**CITRUS COUNTY CENTRAL LANDFILL  
GROUNDWATER  
INVESTIGATION REPORT**

**RESPONSE TO FDEP REQUEST  
FOR ADDITIONAL INFORMATION**

The following information is provided in response to the Florida Department of Environmental Protection (FDEP) May 10, 2006 request for additional information prepared by John R. Morris, P.G. Information is provided in the order requested in the referenced correspondence. In each case, the DEP request is repeated with the response immediately following.

**FIGURE 5**  
GROUNDWATER CONTOUR MAP  
CITRUS COUNTY LANDFILL  
JULY 17, 2006

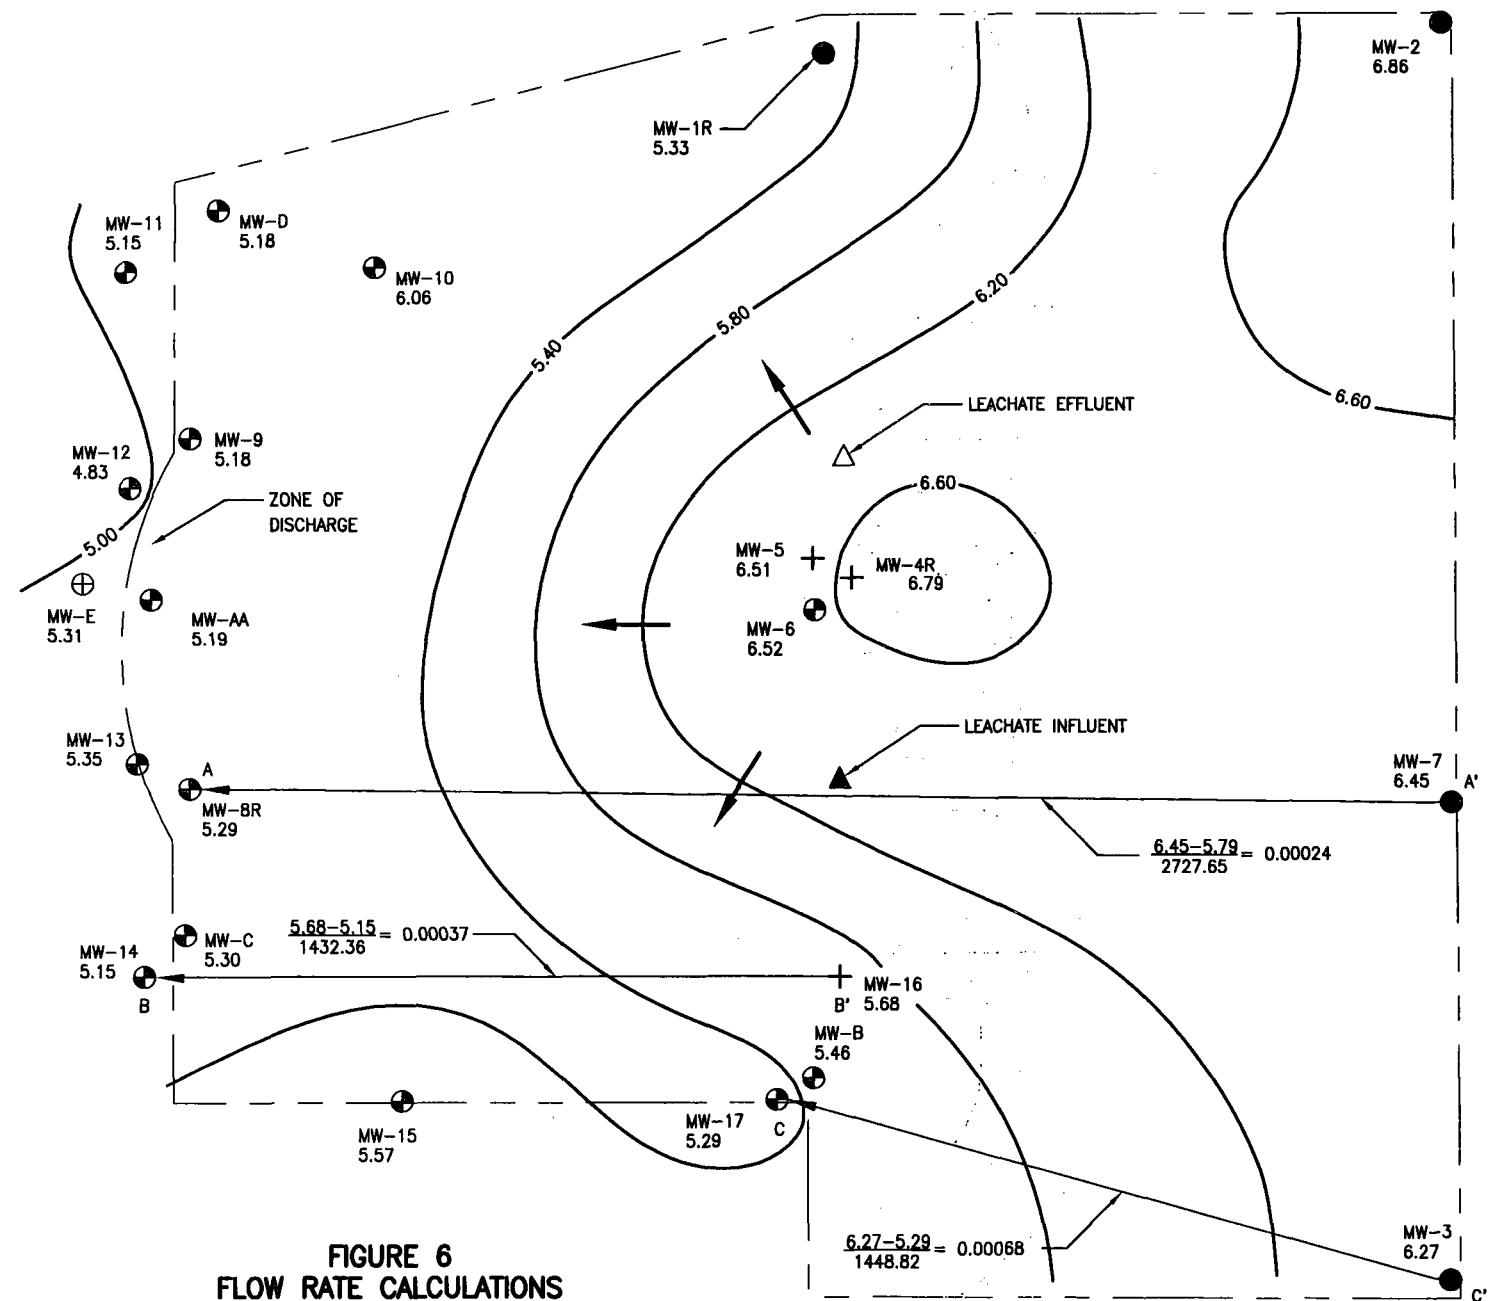
*Comment 3: Please have the Respondent submit revisions to this section to provide a summary of ground water elevation data to be collected during the upcoming supplemental sampling event referenced in review comment No. 1, above. Please have the Respondent submit revisions to this section of the GWR to include a new ground water surface contour map for the upcoming supplemental sampling event.*

**Response 3:** Section 2.4 of the GWIR has been revised to reference groundwater elevation data from the July 2006 sampling event. Table 3 of the GWIR has been revised to include the December 2005 and the July 2006 groundwater elevation data. A new groundwater contour map was prepared with the July 2006 data and is provided as Figure 5 in the GWIR. The revised GWIR is provided as Attachment 1.

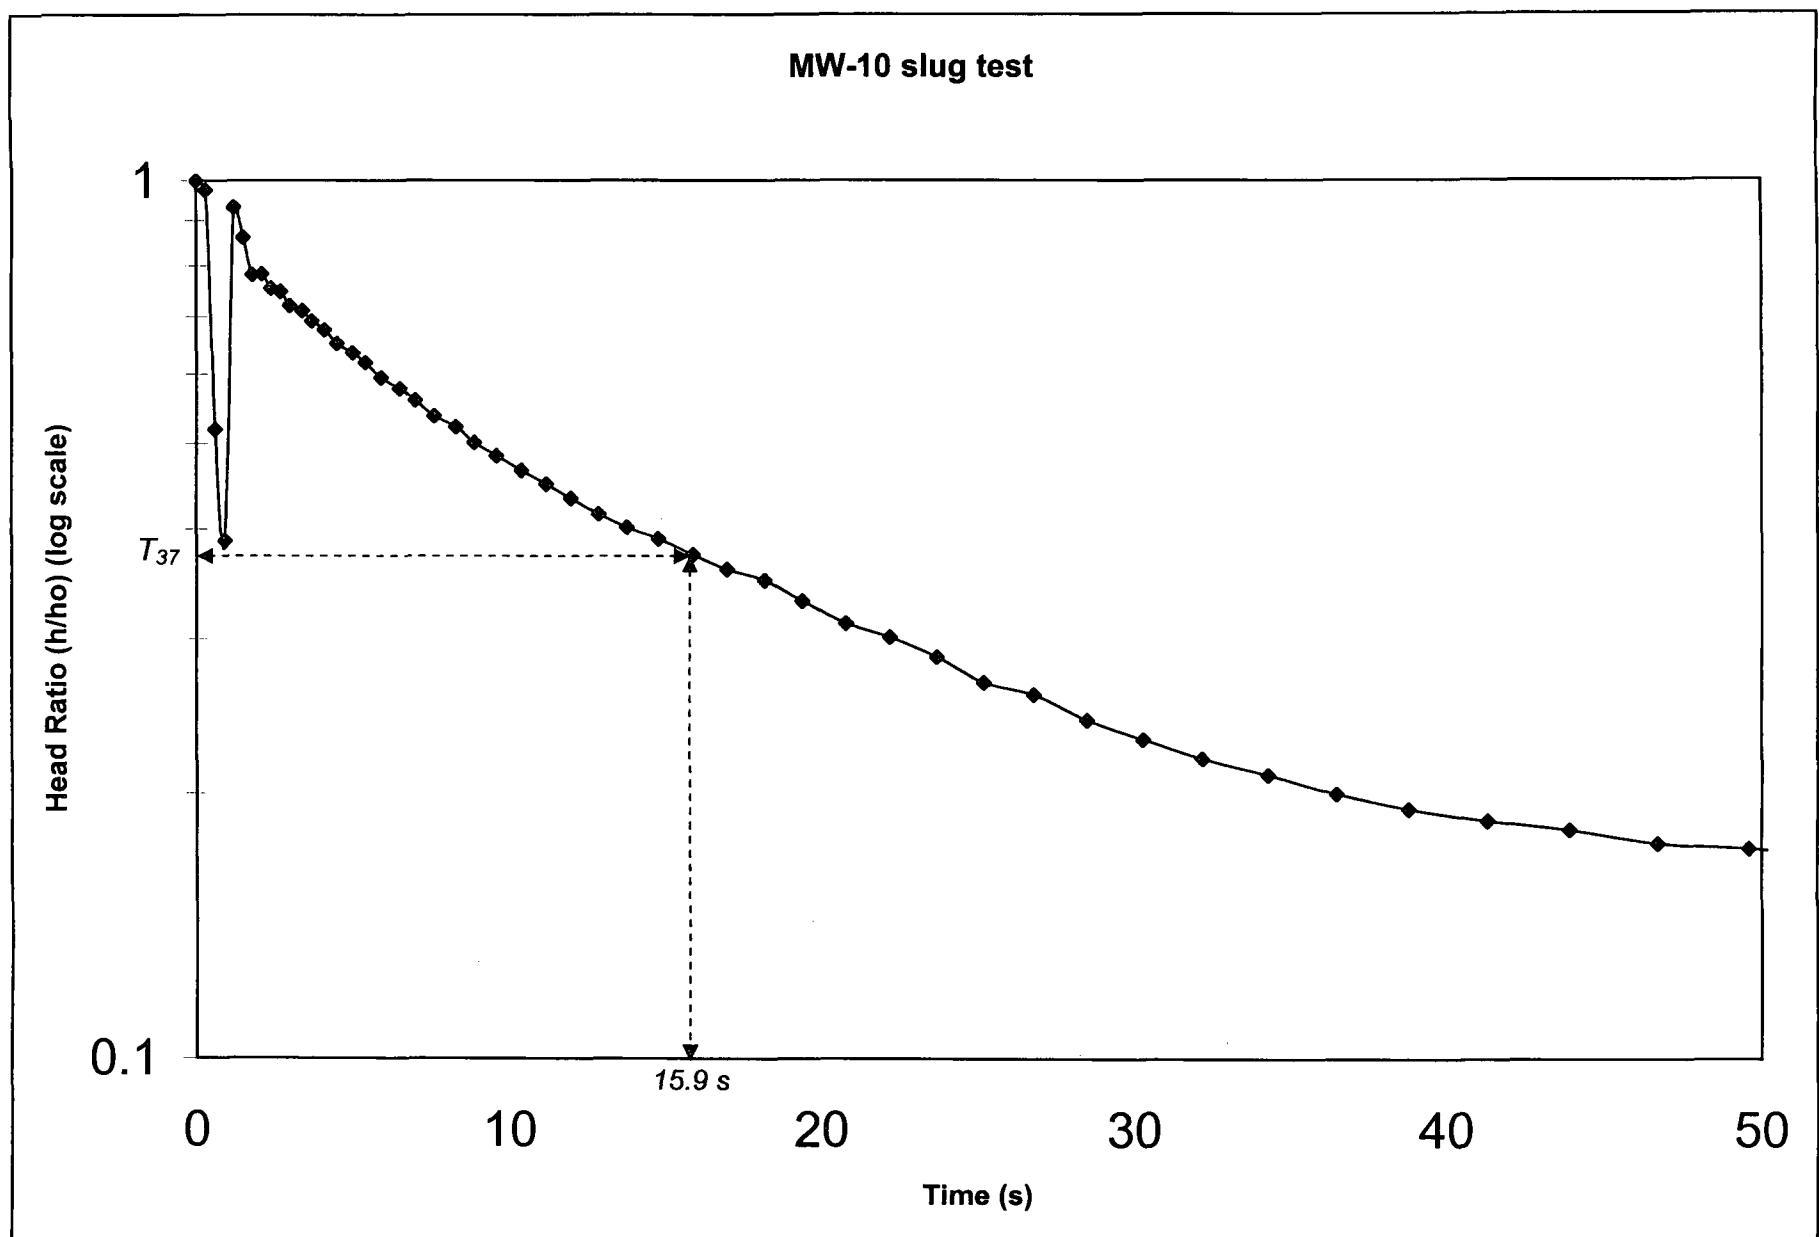
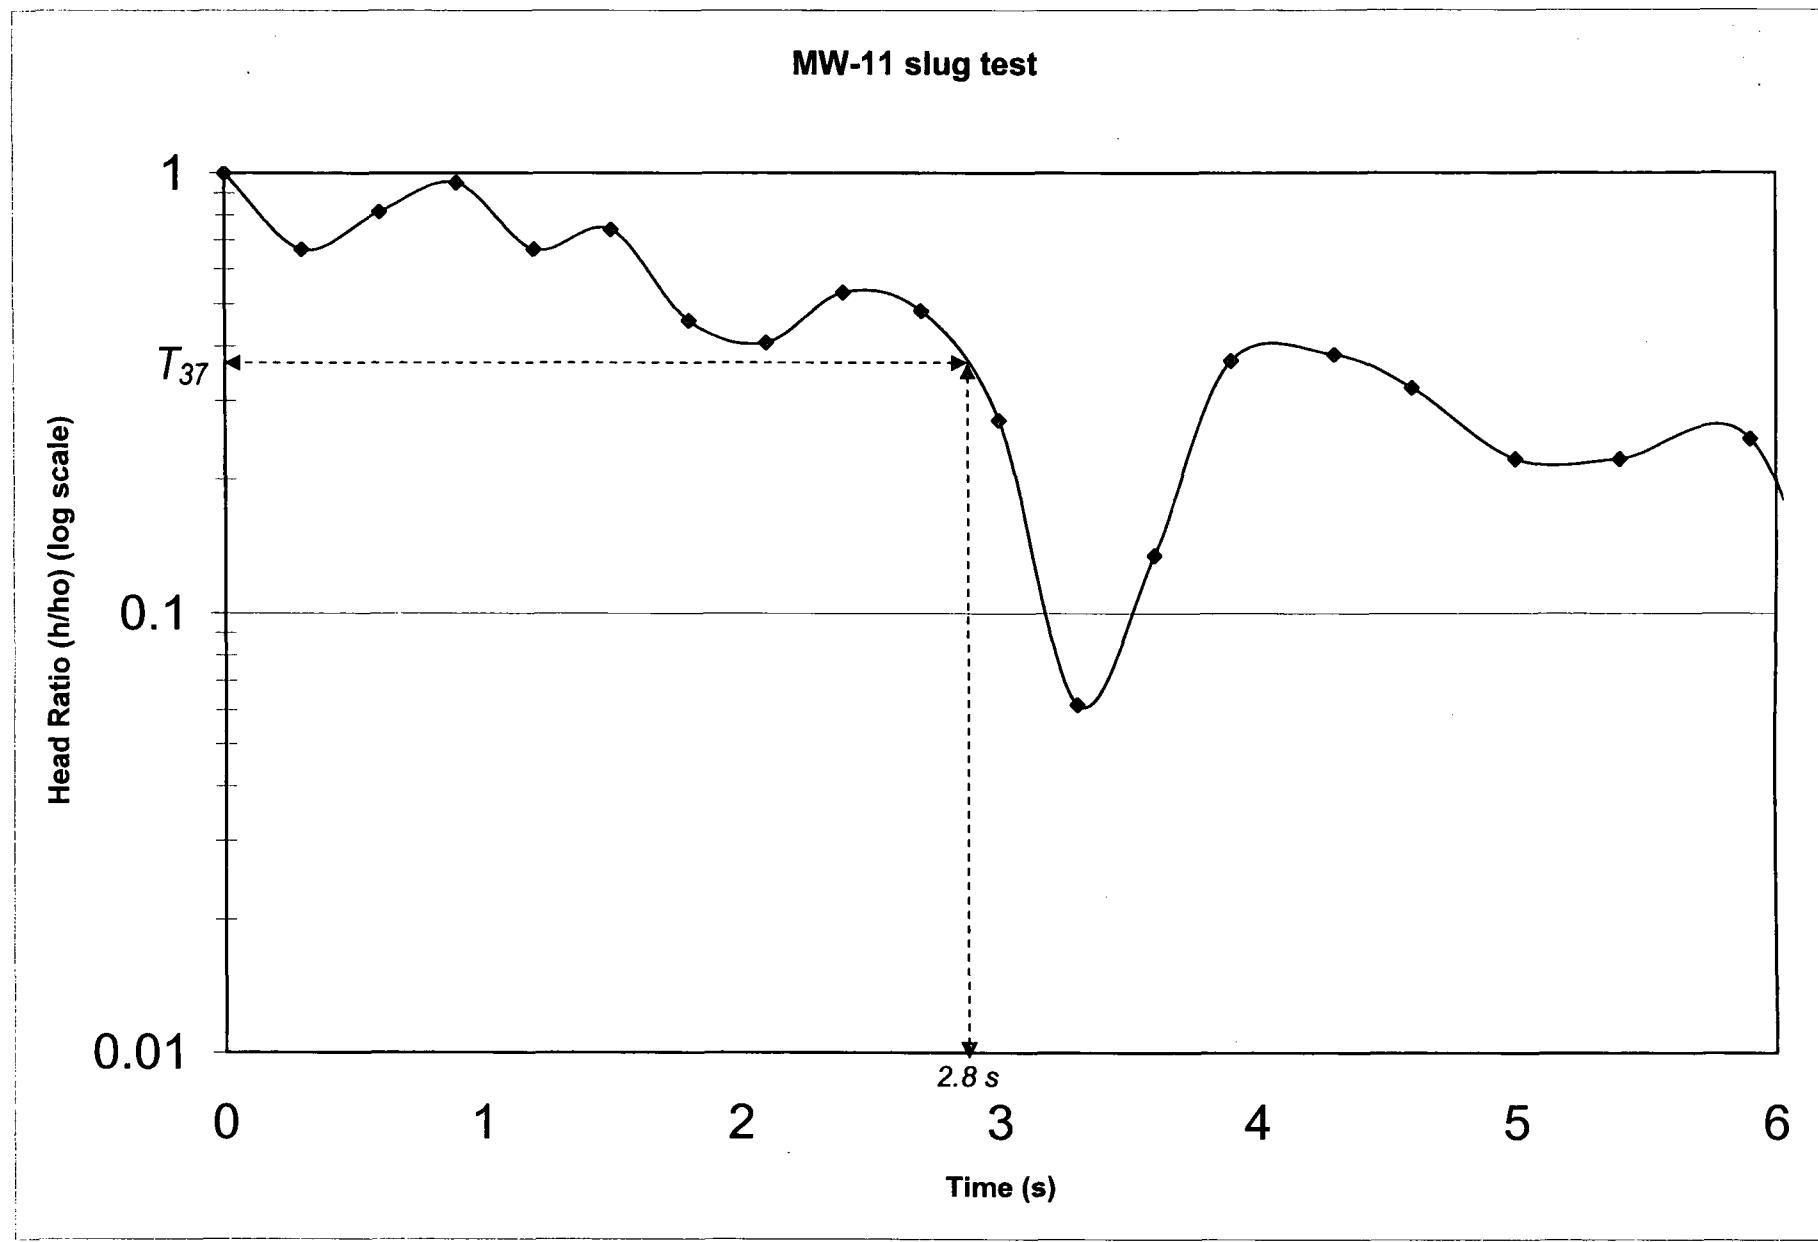
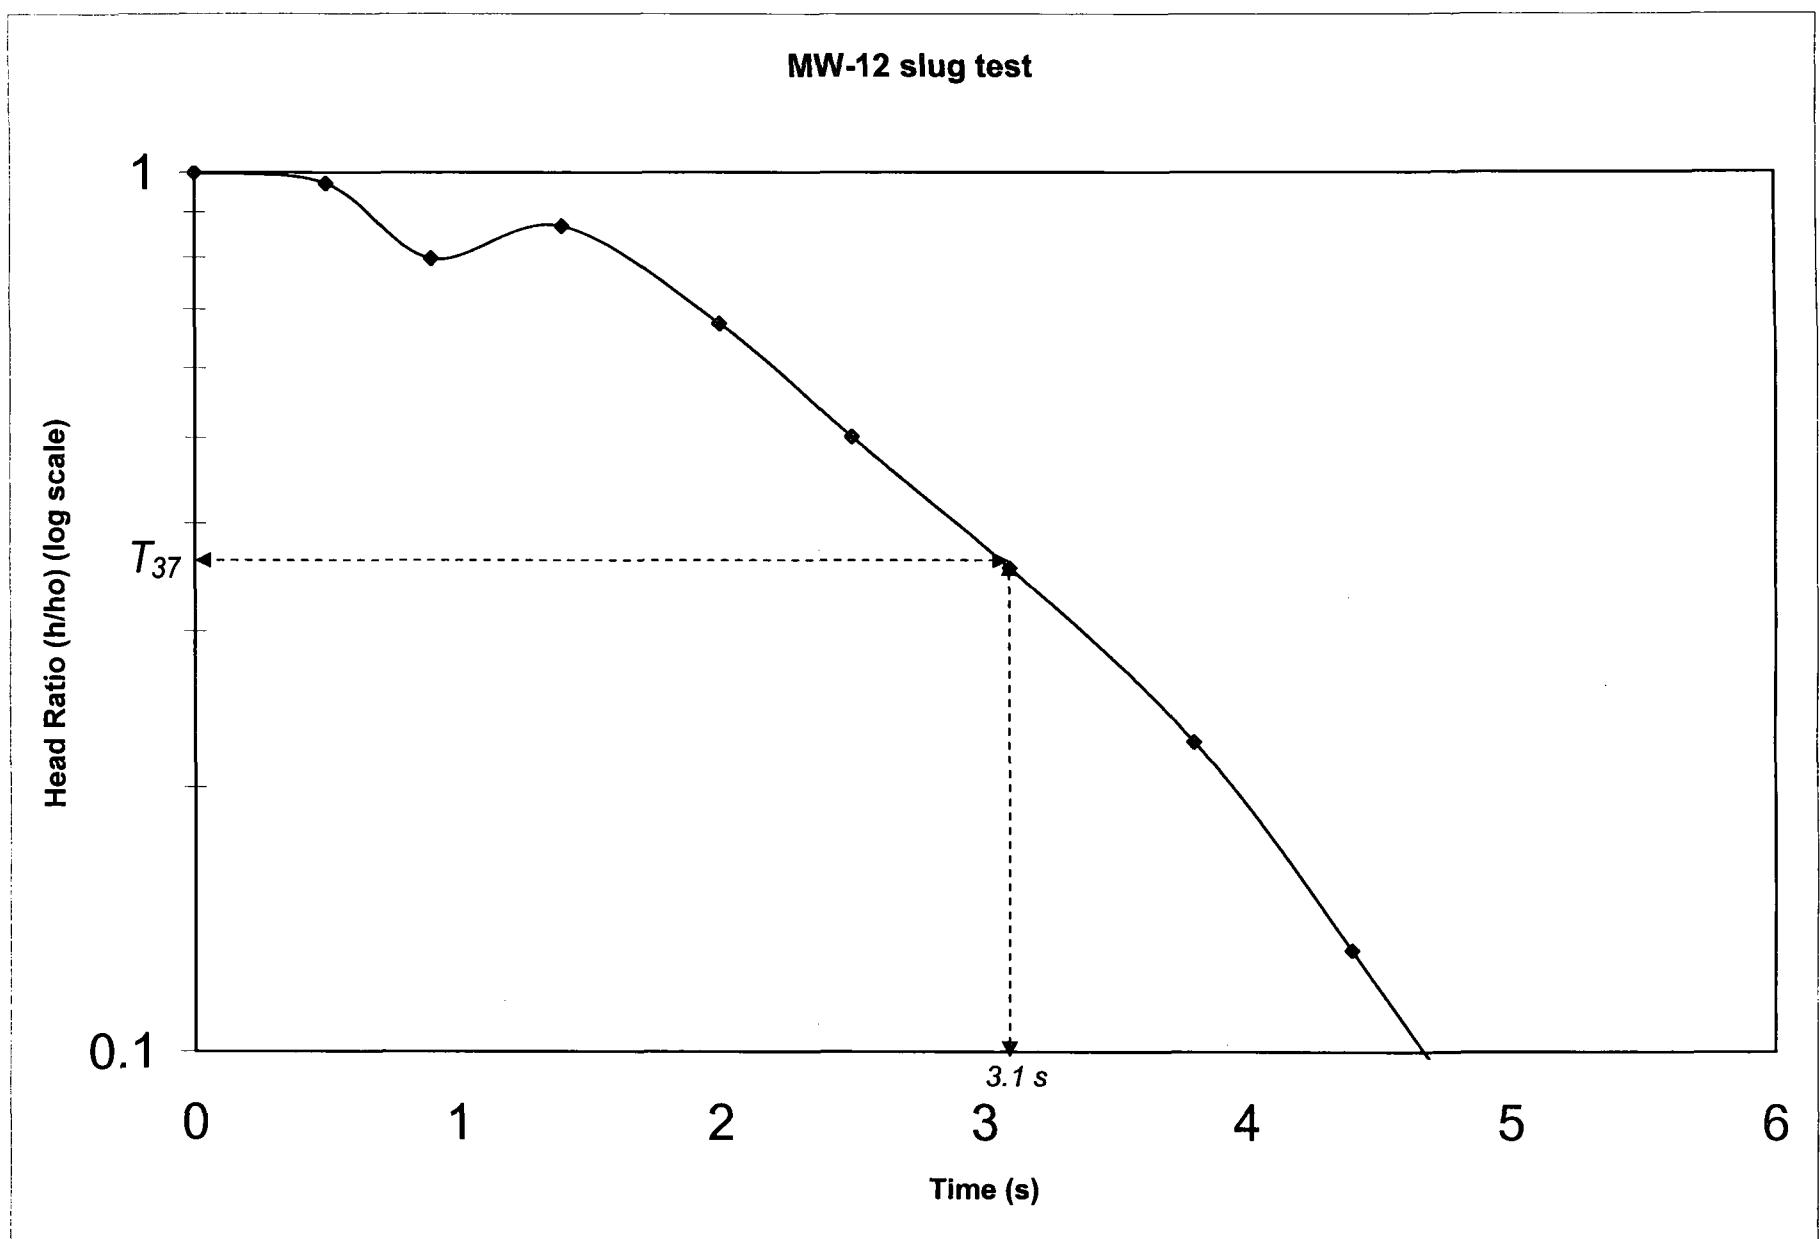
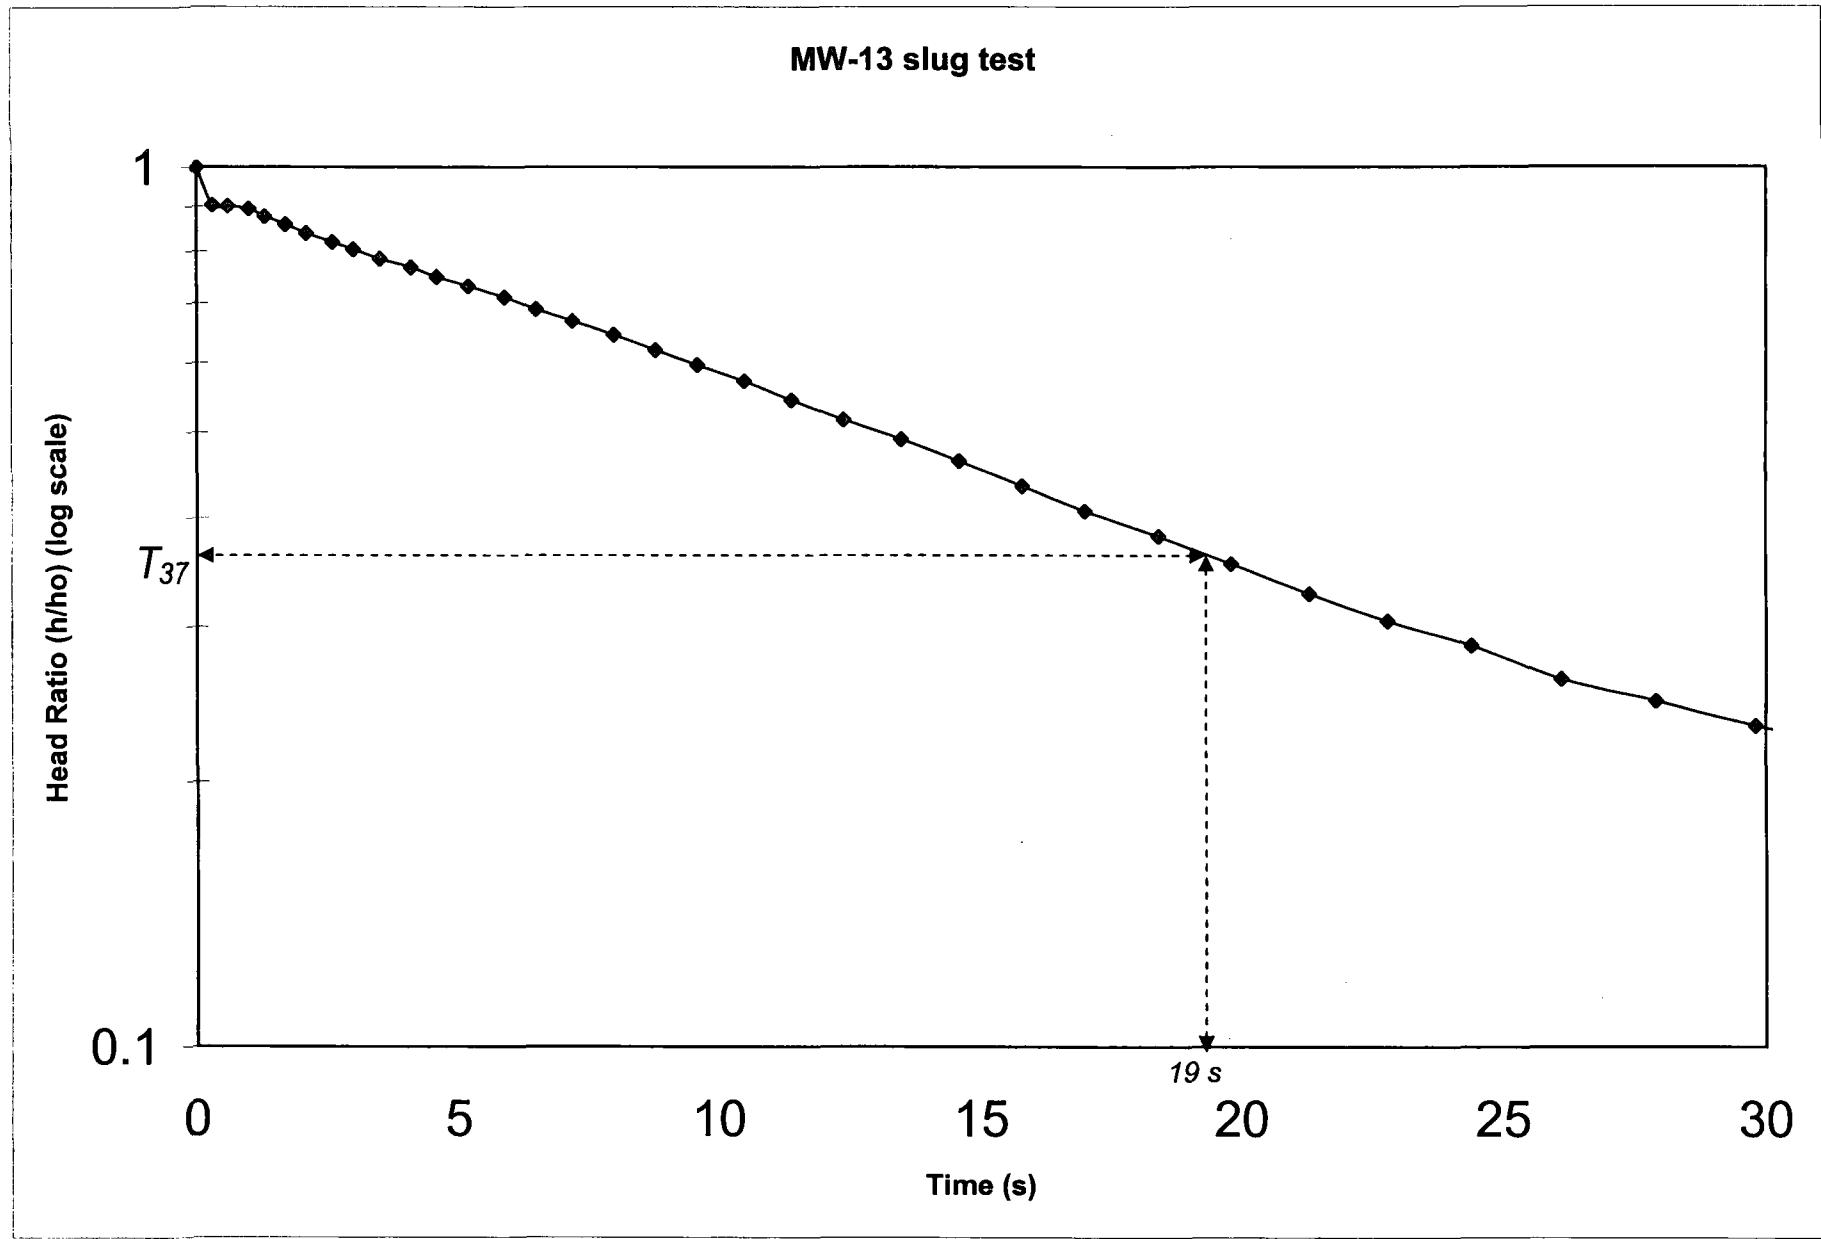
*Comment 4: Field data of residual head vs. time collected during the hydraulic conductivity testing (“slug out” tests) conducted at wells MW-10 through MW-17 were provided in Appendix G. Please have the Respondent submit revisions to Appendix G to also include the graphical solutions prepared for each set of slug test data.*

**Response 4:** Appendix G has been revised (Attachment 1) to include the graphical solutions prepared for each set of slug test data.
